Model: R-C5 Duplex Unit		Date: 3-Jul-09	No.: RD369001
Subject: Parts Catalog Correction		Prepared by: S. Tomoe	
From: 2nd Tech Support Sec. Service Support Dept.			
Classification:	<input type="checkbox"/> Troubleshooting <input type="checkbox"/> Mechanical <input type="checkbox"/> Paper path <input type="checkbox"/> Product Safety	<input checked="" type="checkbox"/> Part information <input type="checkbox"/> Electrical <input type="checkbox"/> Transmit/receive <input type="checkbox"/> Other ()	<input type="checkbox"/> Action required <input type="checkbox"/> Service manual revision <input type="checkbox"/> Retrofit information <input type="checkbox"/> Tier 2

Model: R – C5 Duplex Unit		Date: 14-Jun-10	No.: RD369002
Subject: Guide Plate		Prepared by: T. Nihei	
From: 1st Overseas Tech Support Sec., 1st PQM Dept.			
Classification:	<input checked="" type="checkbox"/> Troubleshooting <input type="checkbox"/> Part information <input type="checkbox"/> Action required <input type="checkbox"/> Mechanical <input type="checkbox"/> Electrical <input type="checkbox"/> Service manual revision <input type="checkbox"/> Paper path <input type="checkbox"/> Transmit/receive <input type="checkbox"/>

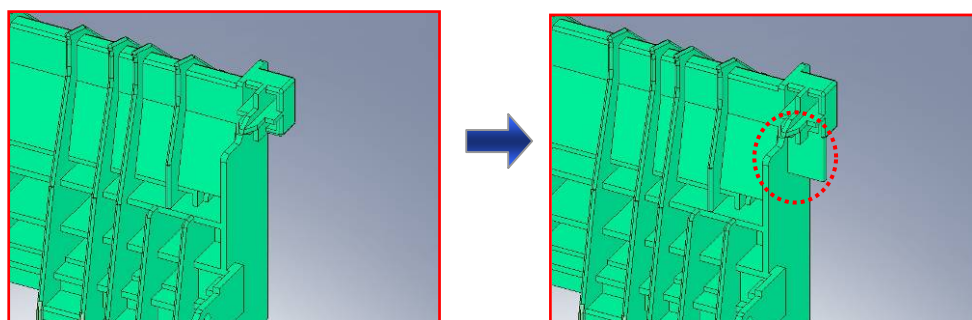
Old part number	New part number	Description	Q'ty	Int	Page	Index	Note
D3694663	D3694677	GUIDE PLATE - OPEN/CLOSE	1-1	X/O	7	22

Change: The shape of the guide plate was changed.

Reason: To ensure that the separation guide plate does not interfere with the movement of the fusing pressure release lever.

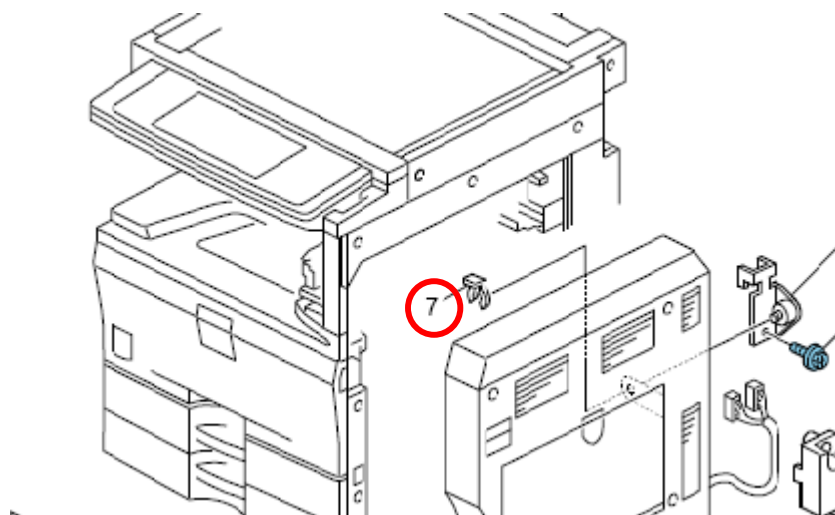
Incorrect part number	Correct part number	Description	Q'ty	Int	Page	Index	Note
B0902622	08050097	RING SEPARATOR			3	7

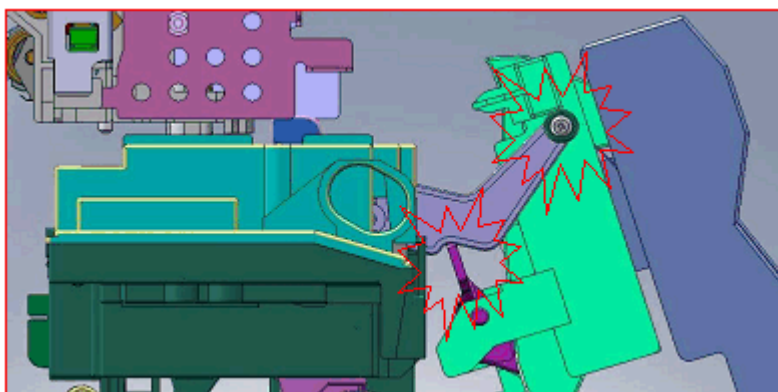
The guide plate and/or lower gate pawl may be damaged when the duplex unit is closed.

Sometimes, the fusing lever gets positioned under the guide plate, which causes the lower gate pawl to press against the fusing lever.

Replace the guide plate with the modified part shown below.

- The shape of the guide plate was changed to ensure that the fusing lever cannot be positioned under the guide plate.
- See RTB #RD369002 for detailed parts information.

New part number	Description	Page	Index	Note
D3694677	GUIDE PLATE - OPEN/CLOSE	7	22
